ADDENDUM NO. 02

Wheatley Institute Third Floor Renovation

Project: Wheatley Institute – 3rd Floor Renovation

ADDENDUM NO. 2

M9243
E1.2

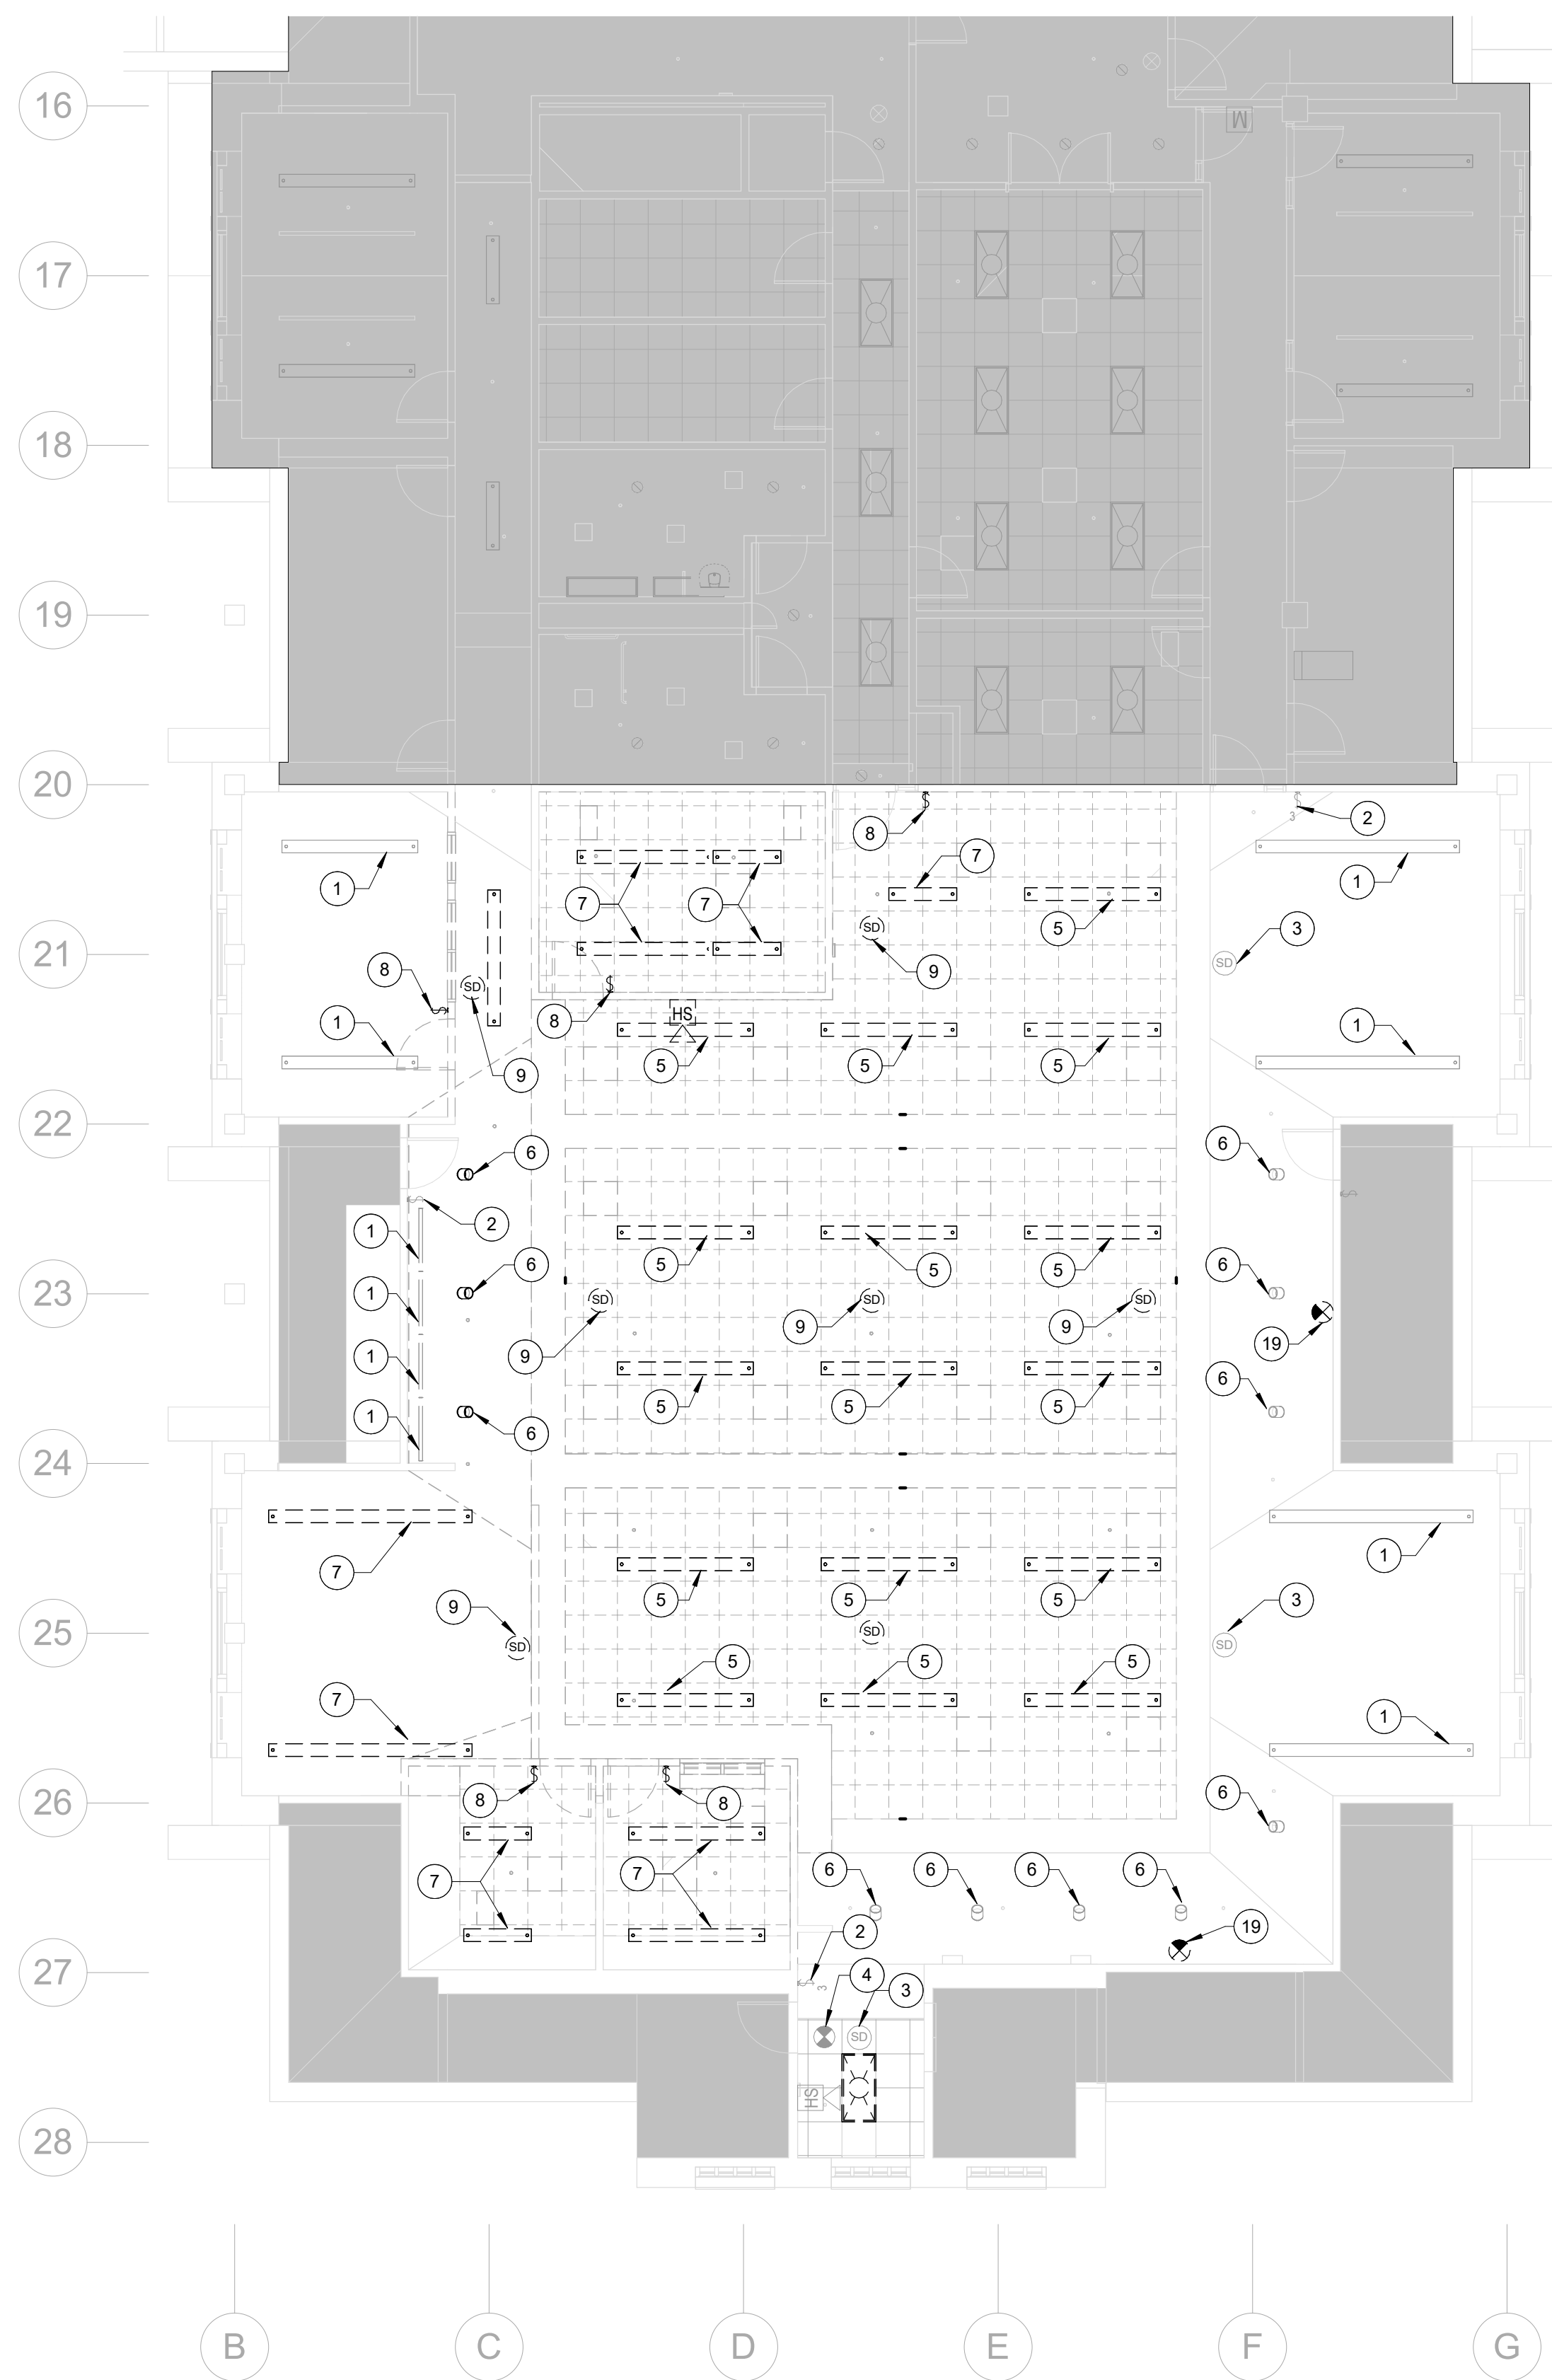
- REVISE: Light Fixture keynote #12 in Initiative #1 room.
- REVISE: Sheet keynote 13 callout information.

6 ELECTRICAL DEVICE MOUNTING HEIGHTS - ELEVATION

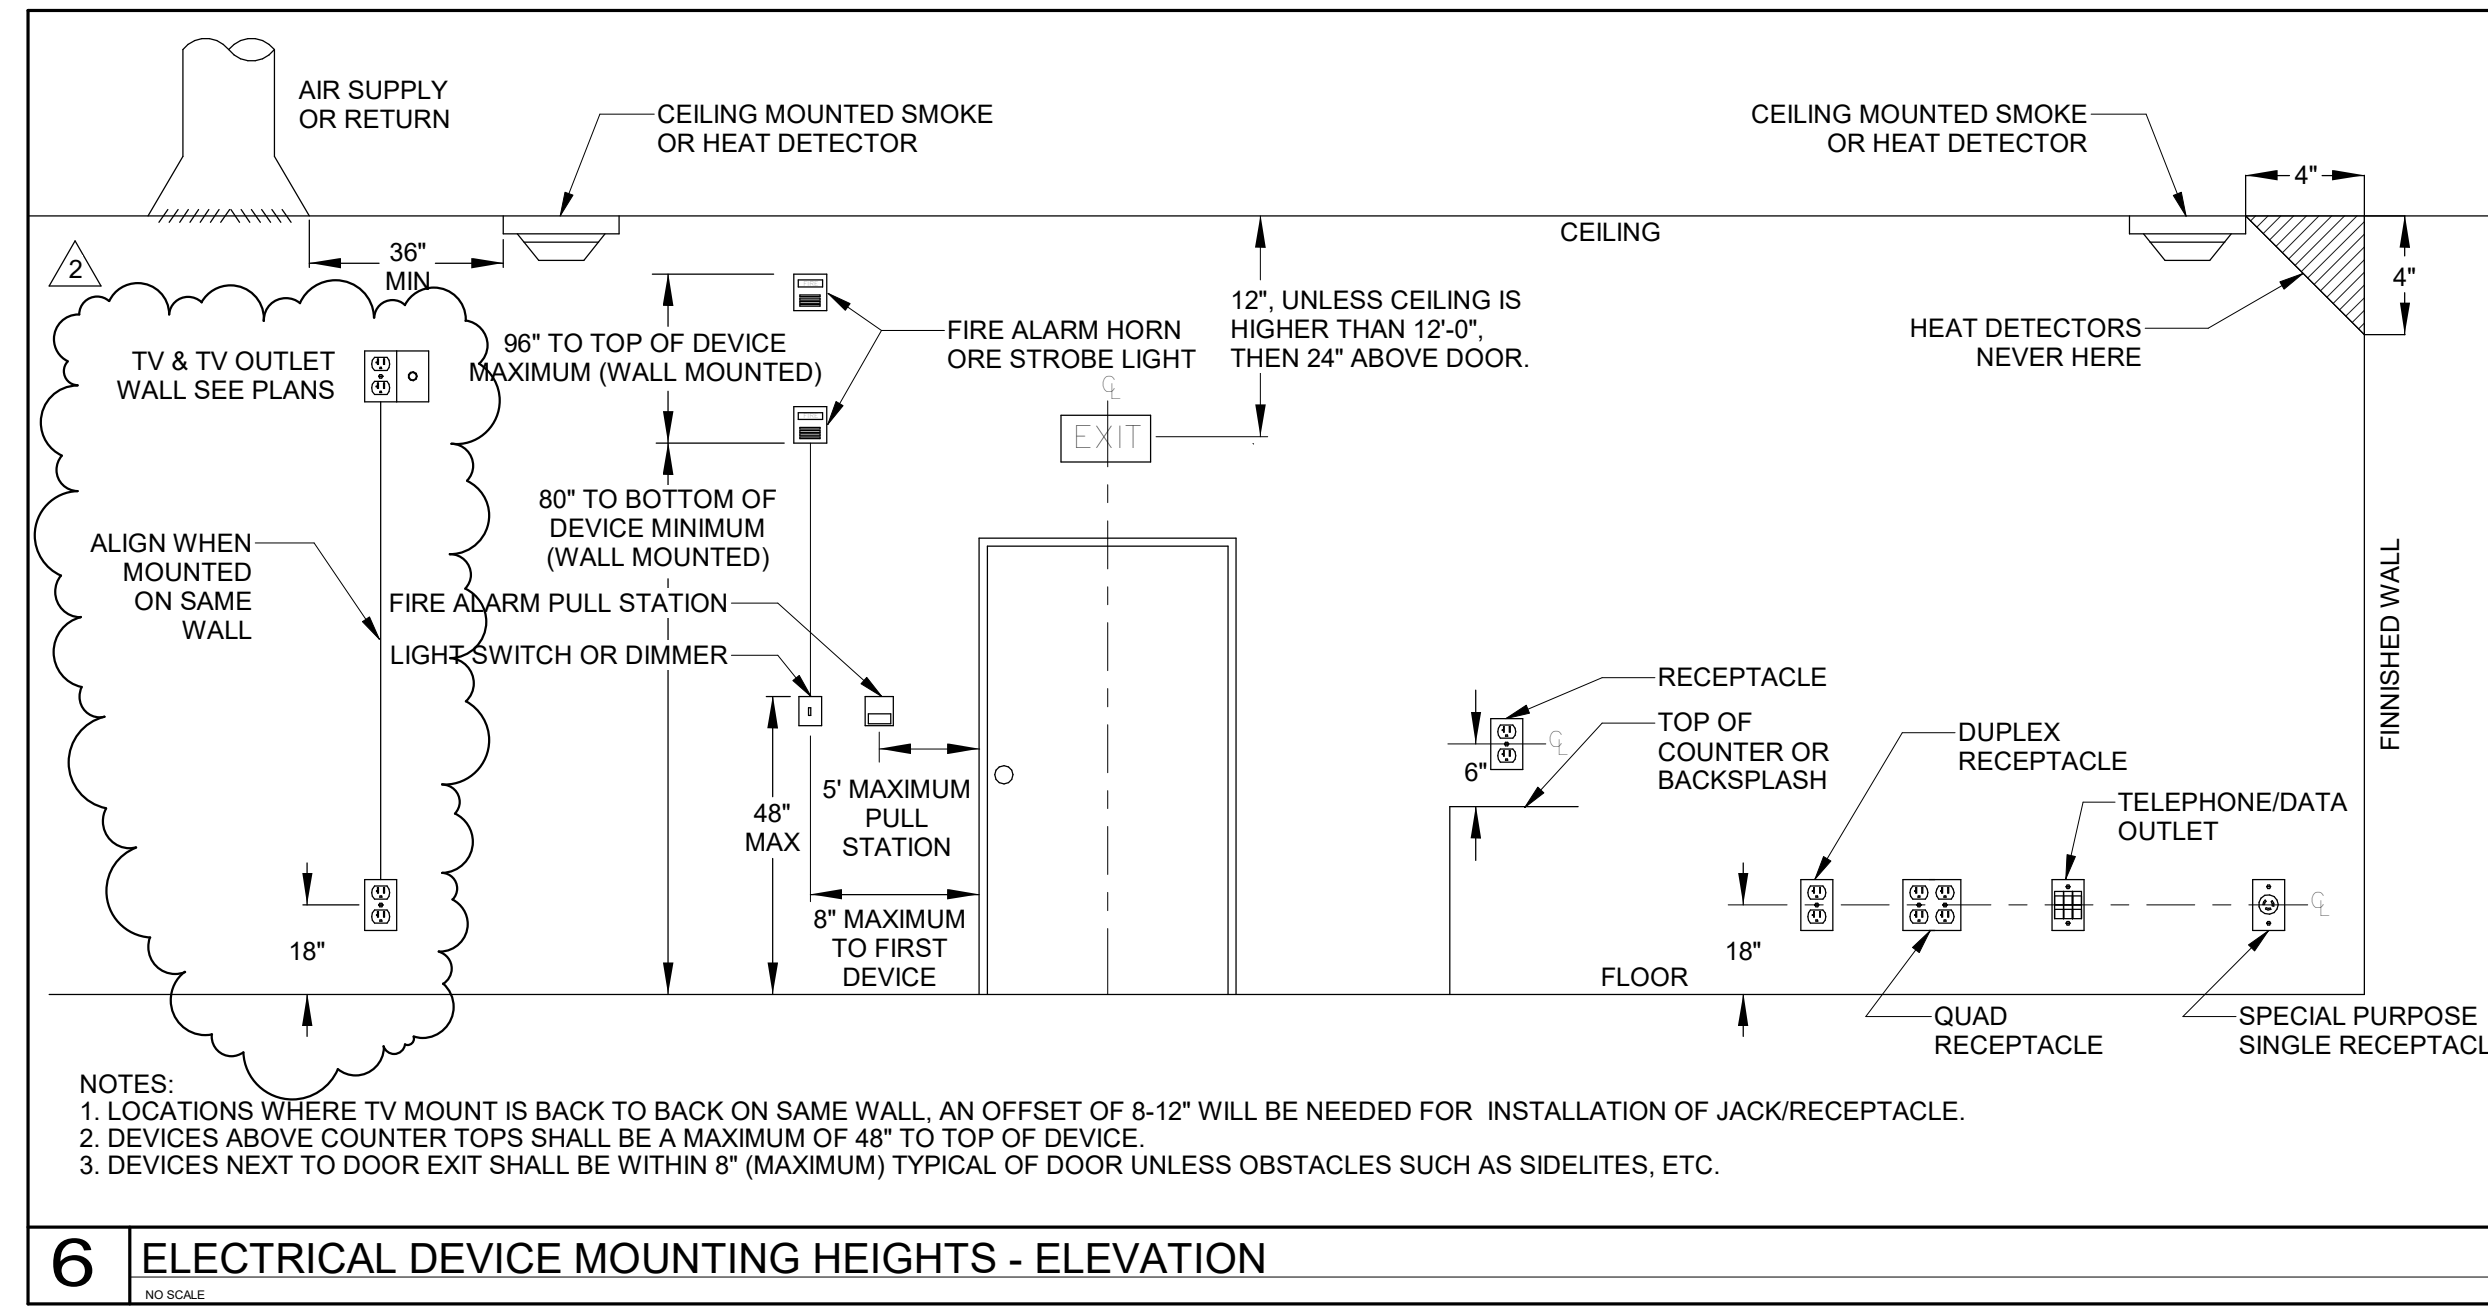
- REVISE: Devices and Pathways legend to show TVSS
- REVISE: Fire Alarm legend to show Fire/Smoke Damper
- REVISE: Detail 6 – Electrical Device mounting Heights – Elevation to show TVSS receptacle.
